CONSTRUCTION PLANS FOR: WATER PUMP STATION AND WATER MAINS

ARAPAHO ROAD PHASE III
 PLAN & PROFILE
 STORM SEWER 'B' STA. 0+85.21 TO STA. 5+00

TOWN OF ADDISON

ARAPAHO ROAD PHASE III
PLAN & PROFILE
STORM SEWER LINE 'A' STA. -1+84.79 TO STA. 0+85.21

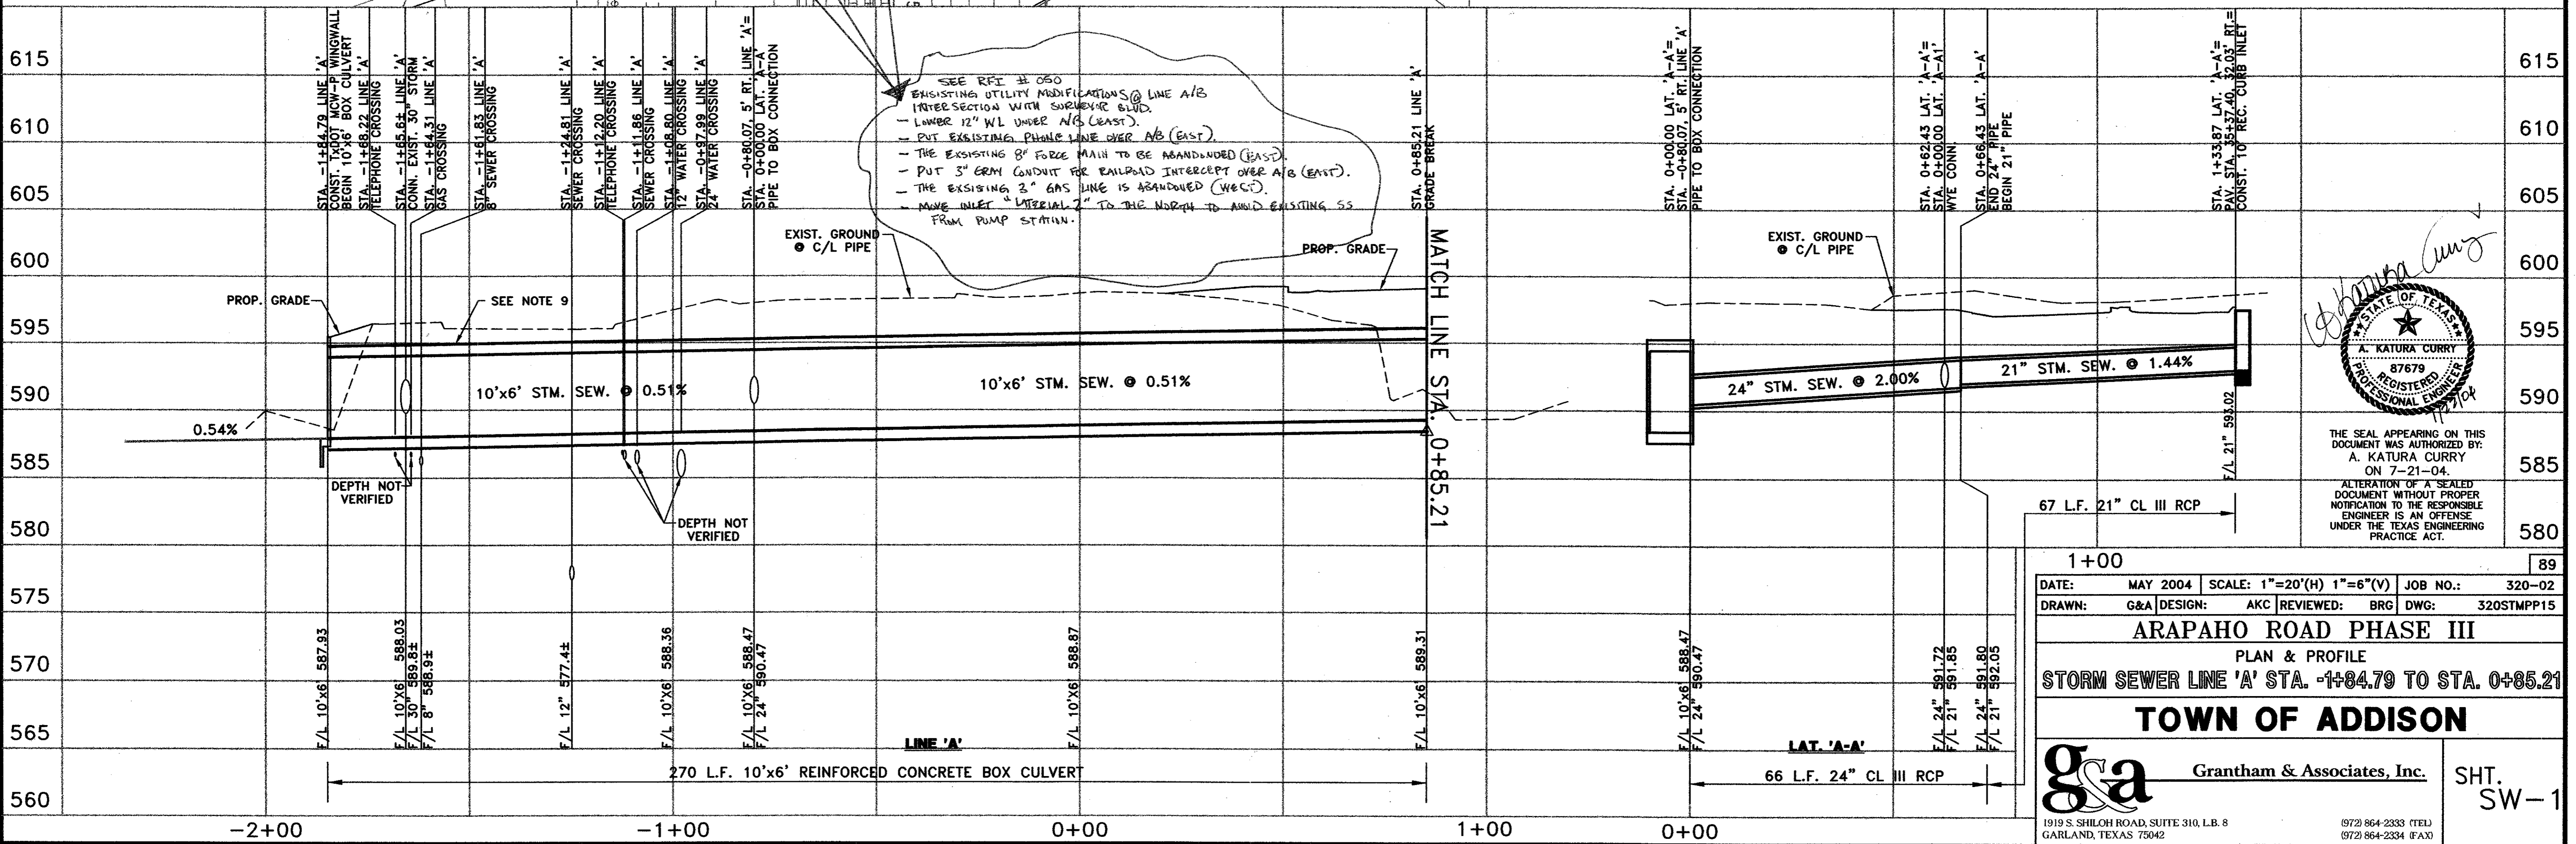
SEE RFI # 027 (SEE SHEET # 21a)
GRADED PIPE DETAIL

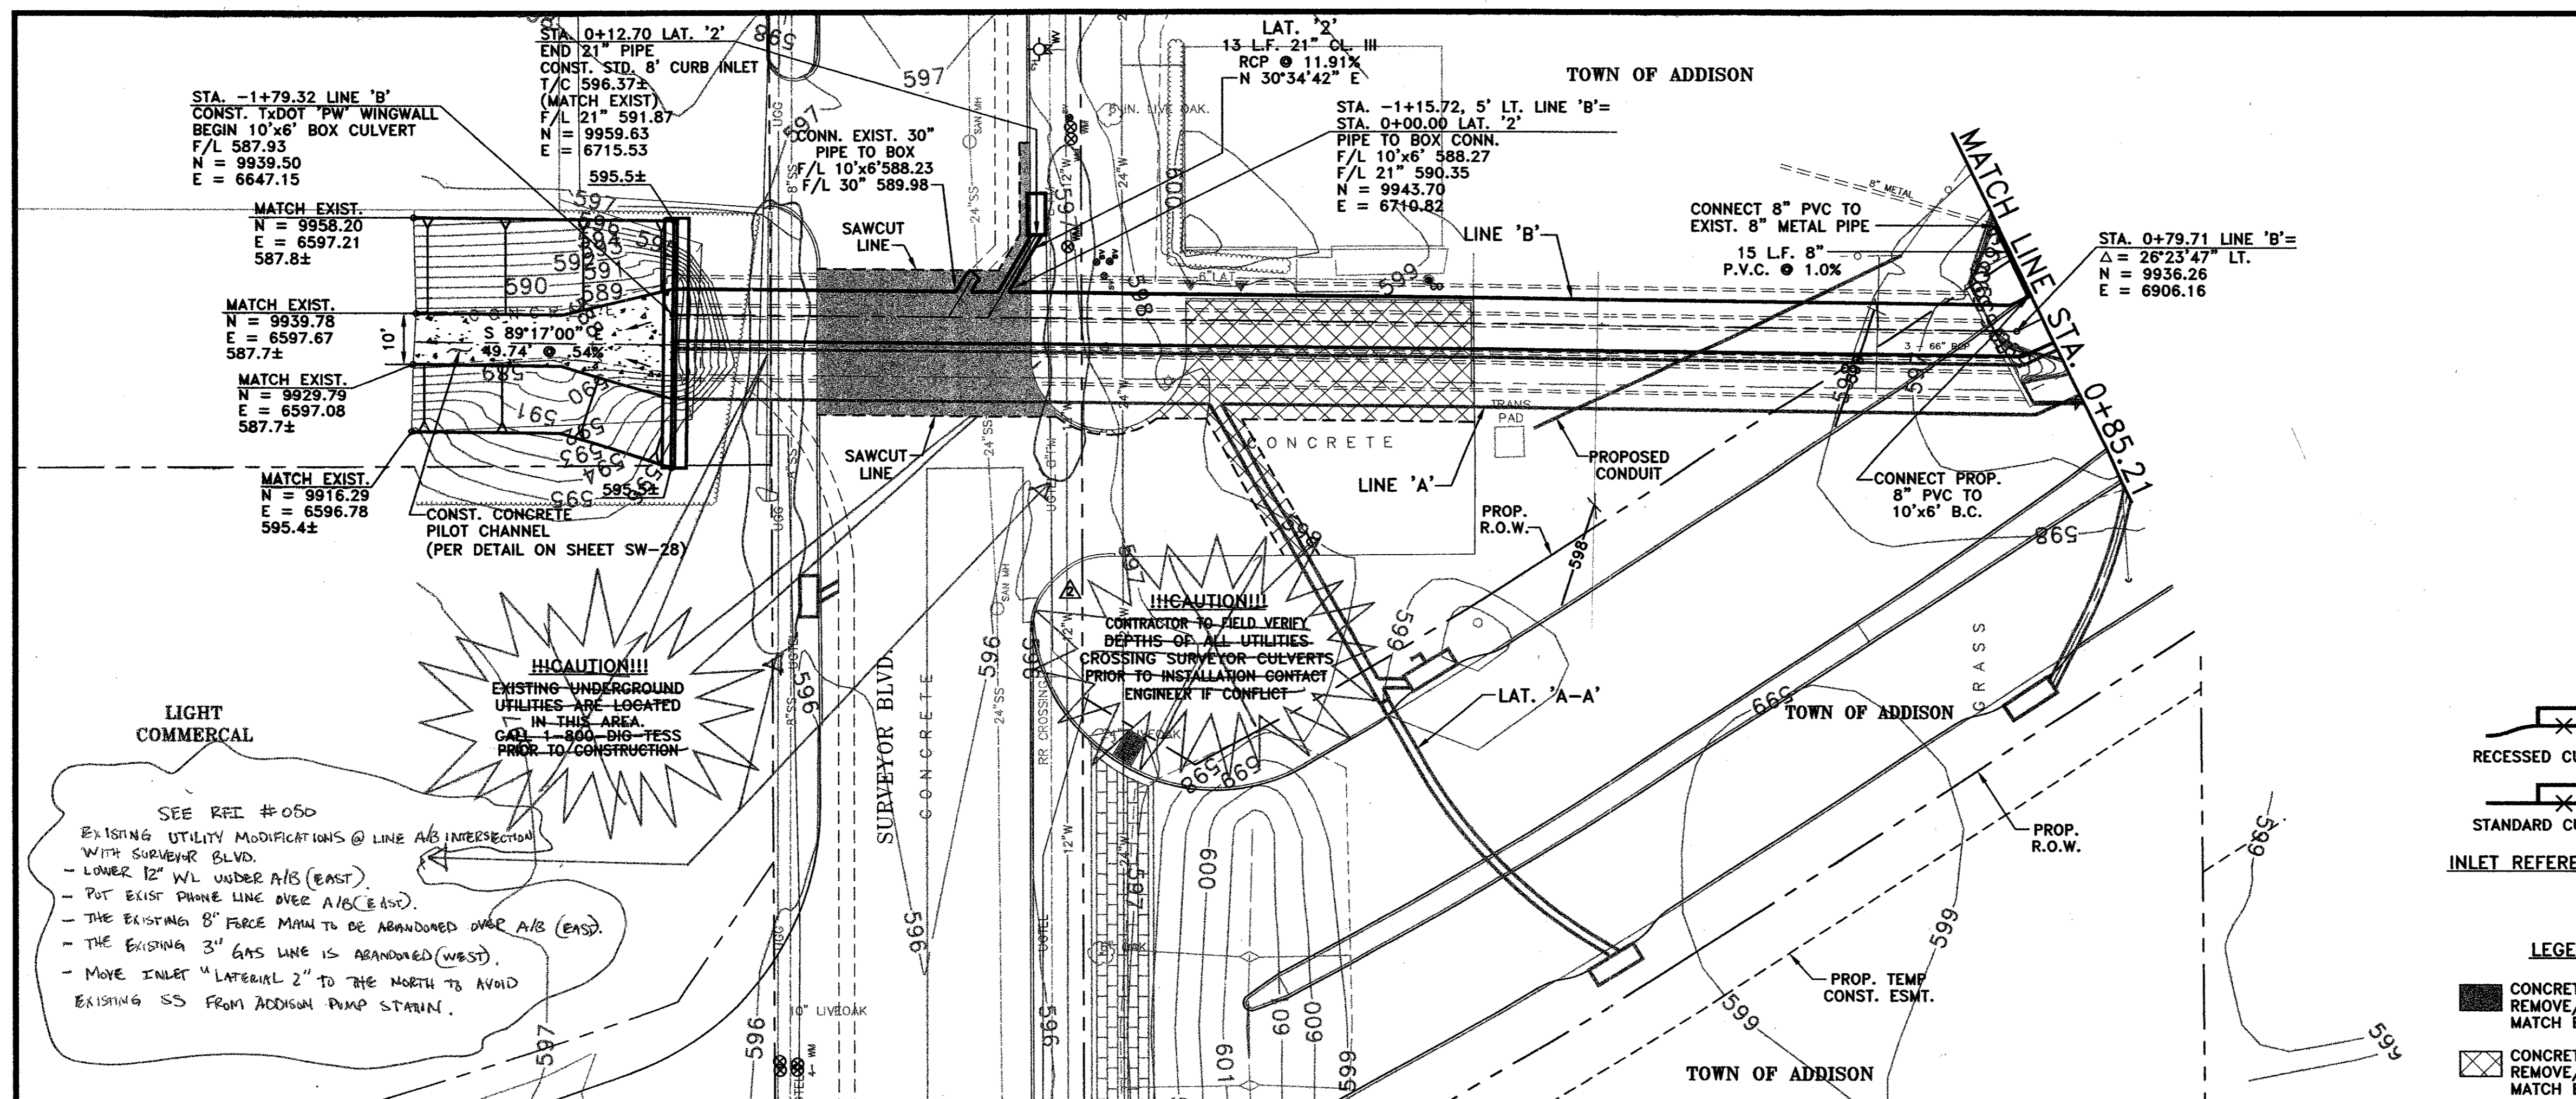
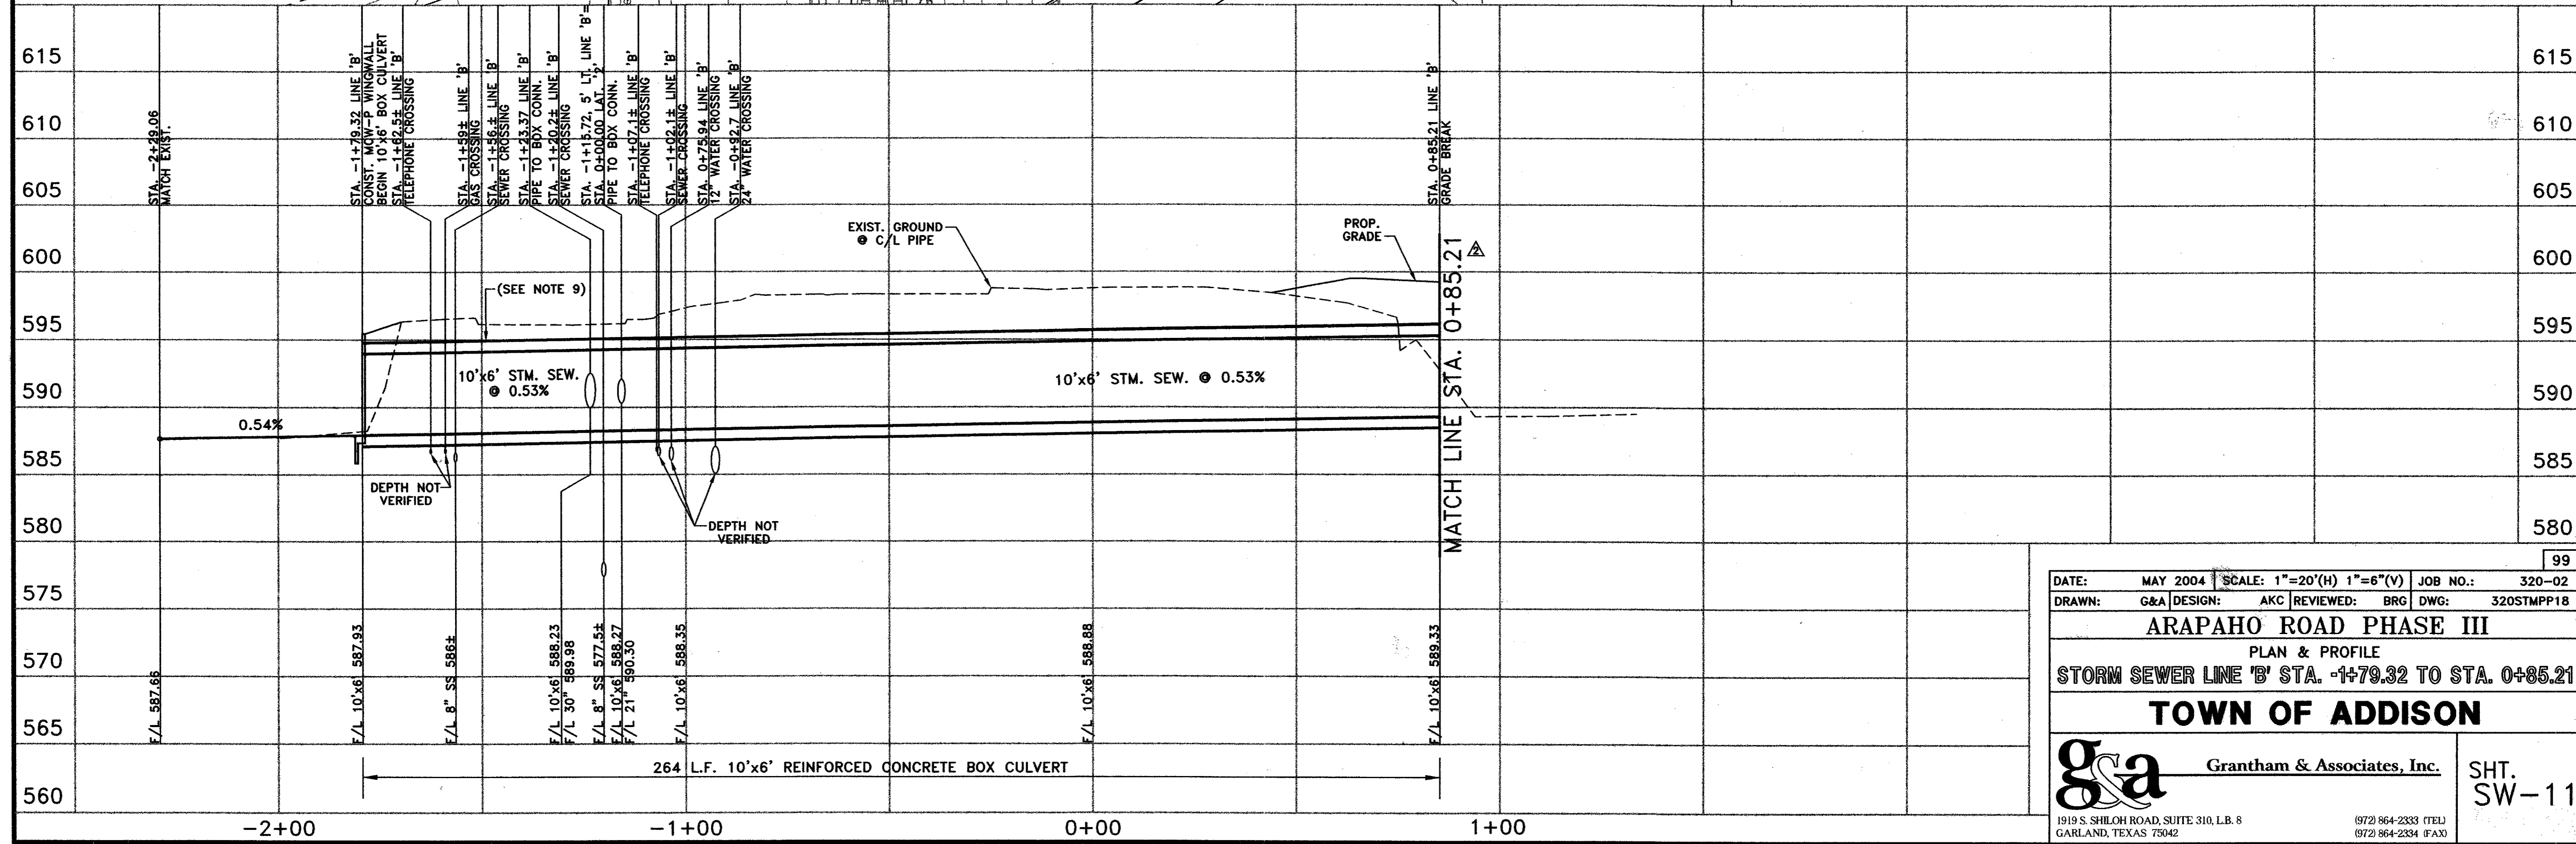
SEE REF # 060
 EXISTING UTILITY MODIFICATIONS @ LINE A/B INTERSECTION WITH SURVEYOR BLVD.
 - LOWER 12" WL UNDER A/B (EAST).
 - PUT EXIST PHONE LINE OVER A/B (EAST).
 - THE EXISTING 8" FORCE MAIN IS TO BE ABANDONED OVER A/B (EAST).
 - THE EXISTING 3" GAS LINE IS ABANDONED (WEST).
 - MOVE INLET "LATERAL 2" TO THE NORTH TO AVOID EXISTING SS FROM ADDISON PUMP STATION.
